Planning Application S/2876/16/OL - Development off Rampton Road, Cottenham

Cottenham Parish Council has considered the recently submitted revised **Transport Assessment, Travel Plan** and **Heritage Impact Statement** and offers these comments in support of its continued strong objection to the development.

Fig 2: Proposed "improvement" to Oakington Road / Rampton Road roundabout

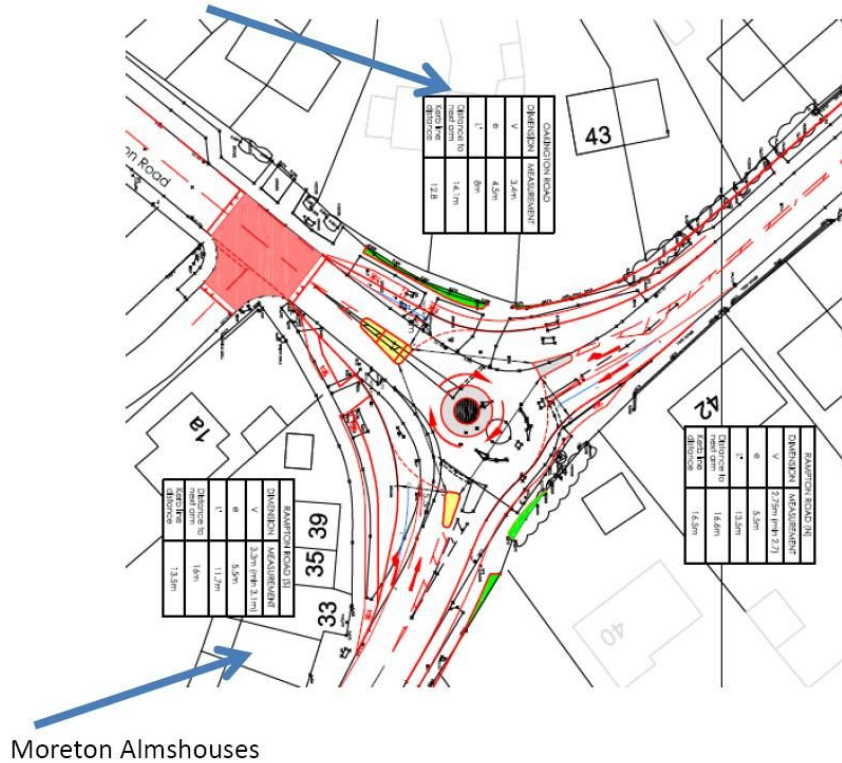
The Gladman-proposed solution has serious consequences for residents of Rampton Road, some of Oakington Road – especially #2 and #4 whose driveways would enter the new roundabout directly – and the Grade II Listed Buildings - the John Moreton 1853 Almshouses.

#2 and #4 Oakington Road hidden under table

The proposed changes inherently affect the views to and from the Listed Buildings (4.38 of the SDC SPD "Listed Buildings: Works to or affecting the setting of"

Fig 4: Illustrative view of the effect on the setting of the almshouses (on left of diagram)

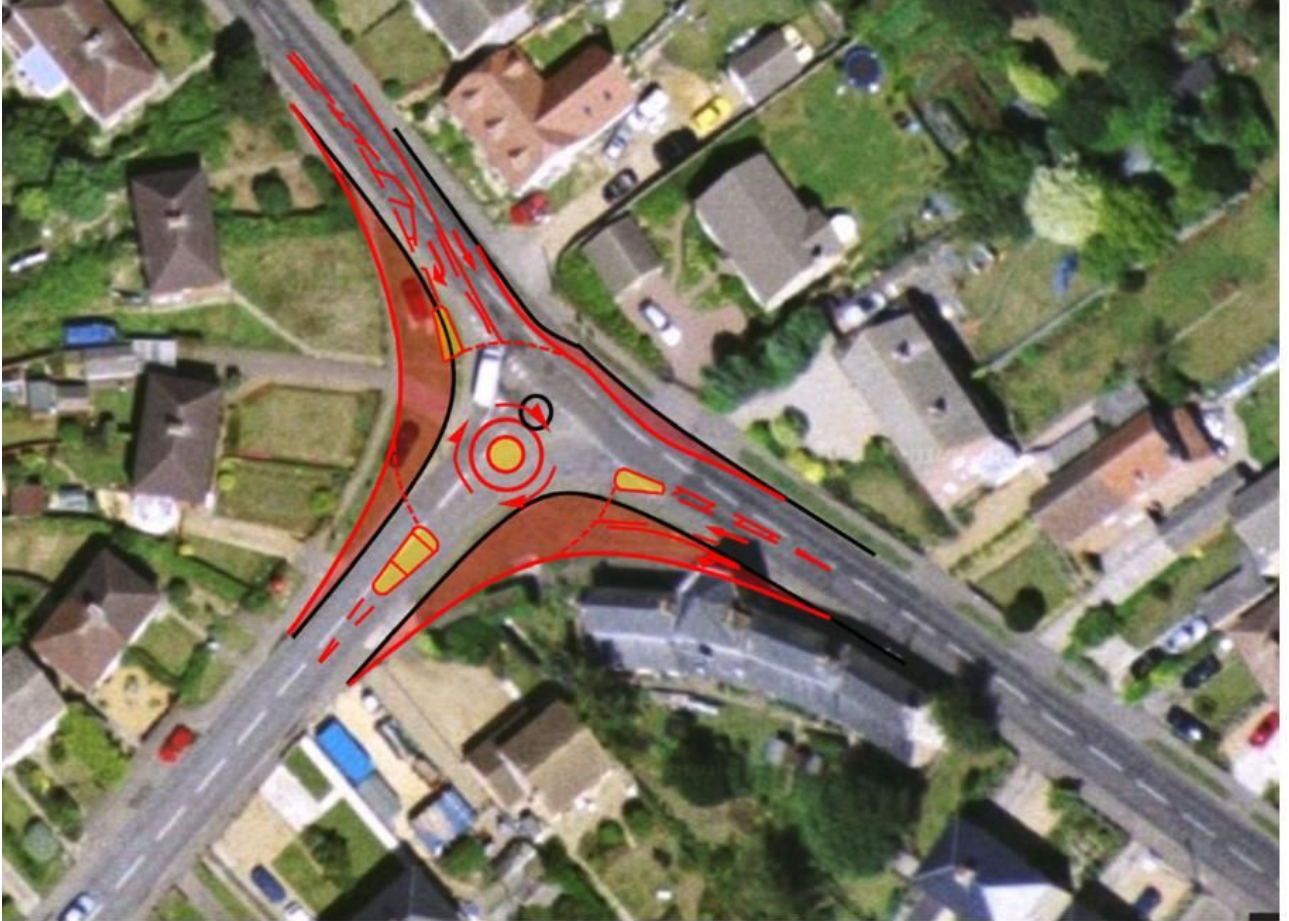
This roundabout is within the setting of the **Grade II listed 1853 Moreton almshouses** and, with the loss of its village green, would bring much more traffic closer. Increased vibration will compromise these foundation-less buildings. Cyclists and residents, especially the elderly residents of the almshouses (#25-#39 Rampton Road) but also the properties that front directly onto the existing roundabout (#40, #42, and #43 Rampton Road, #2 and #4 (Oakington Road) will be exposed more intimately to more noise, pollution, and safety threats. especially by larger articulated vehicles manoeuvring around, and often across the roundabout. The number of elderly neighbours to the roundabout must require a higher than usual standard of road safety, otherwise these seven, otherwise truly affordable, homes will become impossible to let to those who most need them, nullifying any supposed benefit from the handful of affordable homes possibly deliverable within 5 years as part of the proposal. The long-term social and economic viability of the almshouses themselves is threatened. These buildings are not a just historic work of art to be conserved and admired at a distance, they are homes to some of our most vulnerable residents whose quality of life is threatened.
